Cover Letter (Page 1 of 2)

FCC ID: S9GT300

This project is a Permissive Change II submission for the purpose of

Adding additional antennas to existing grant.

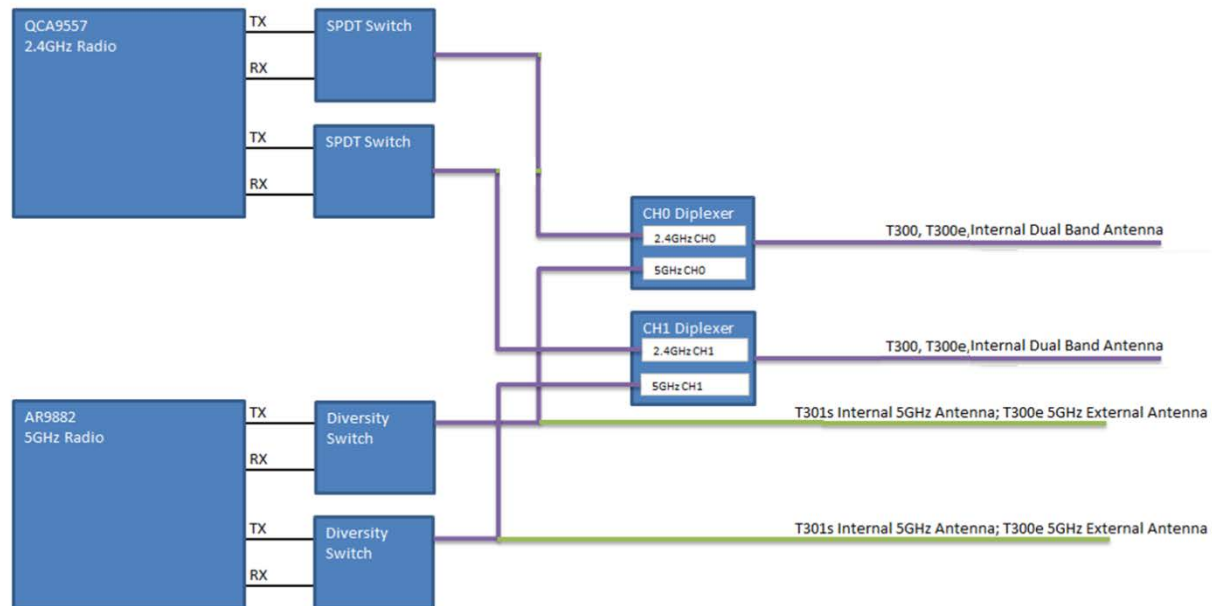
PCB used for the T300 and T300e are identical. The T300e uses the same integrated omni-antenna as the T300. The only difference is that external antennas are supported in 5GHz band. The outputs for the external antennas are switched using the diversity switches at the AR9882 5GHz radio. No additional components are depopulated/populated to compensate for the external antenna. See block diagram below for additional information.
